SITE INSPECTION REPROT

PANKHA 30 MLD STP

Date of Inspection	08/01/2022
PE Inspection Team & KRMPL Personnel	Mr. Sunil Basutkar – Mechanical Expert, STC Kanpur Mr. Rohit Suman-Support Engineer-Mechanical, STC Kanpur Mr. Rahul- Support Engineer- Electrical, STC Kanpur Mr. Satendra Sharma - Support Engineer- Civil, STC Kanpur ----- Mr. Shawaz - Mechanical Engineer Mr. Raman Kundu – Electrical Engineer, KRMPL Kanpur
LOCATION	STP 30 MLD PANKHA

Following are the observations of PE against the RFI raised by KRMPL dated 05.01.2020

1. Manual Screen (I&D Thermal Nala A):

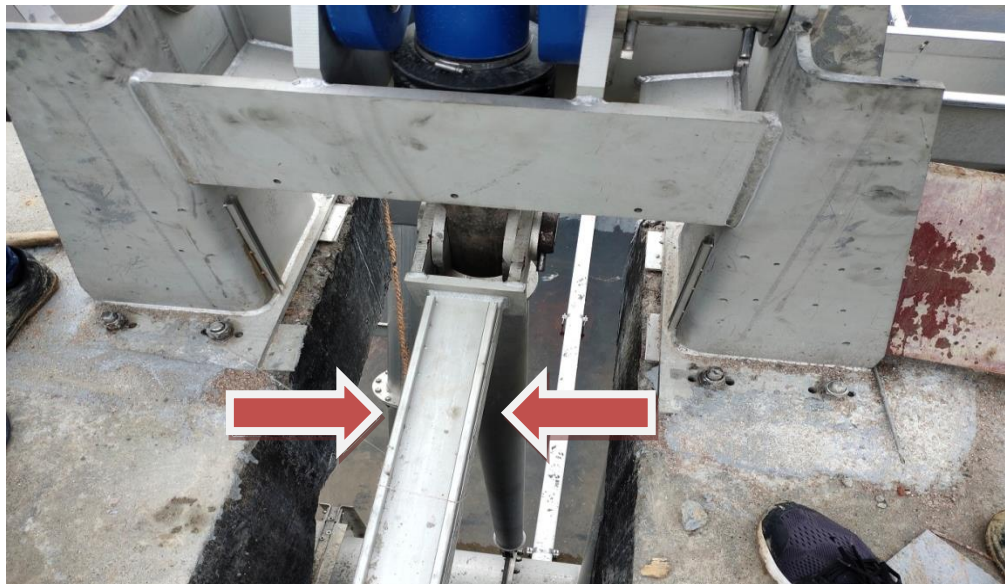
- Installation of manual screen was not found as per the drawing, the differences as under;
- Anchor fasteners were found missing at several places.
- Upper section of the manual screen was found approx 1 ft. above RCC slab which should suppose to fix at the level of RCC slab for proper fixing.

5. Air Blowers 1 & 2 / Blower Cabling/ Cable tray / LPBS:

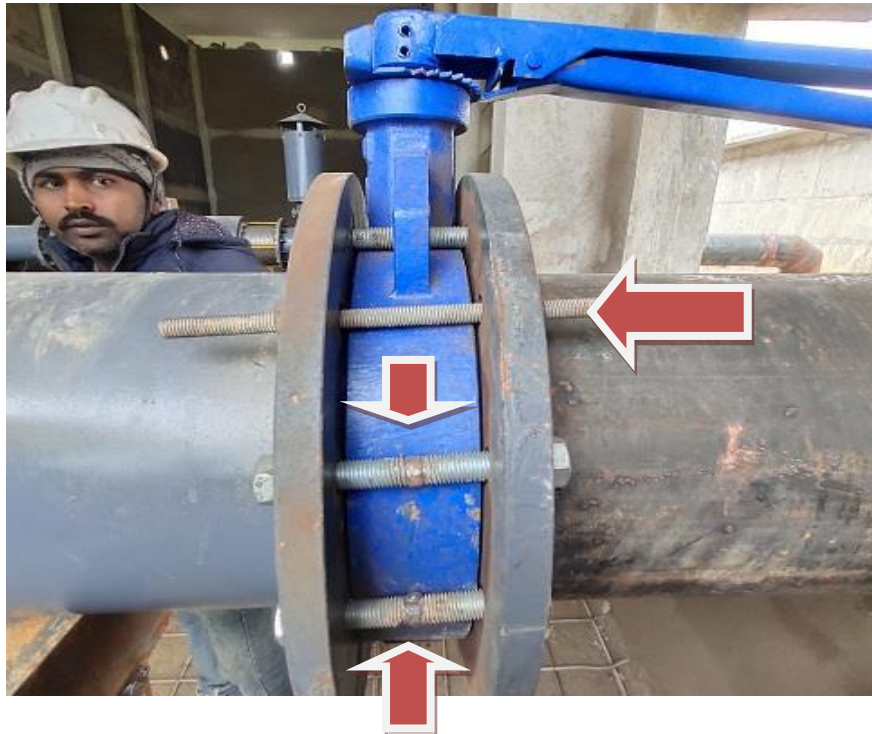
- Pulley safety guard was not found fixed.
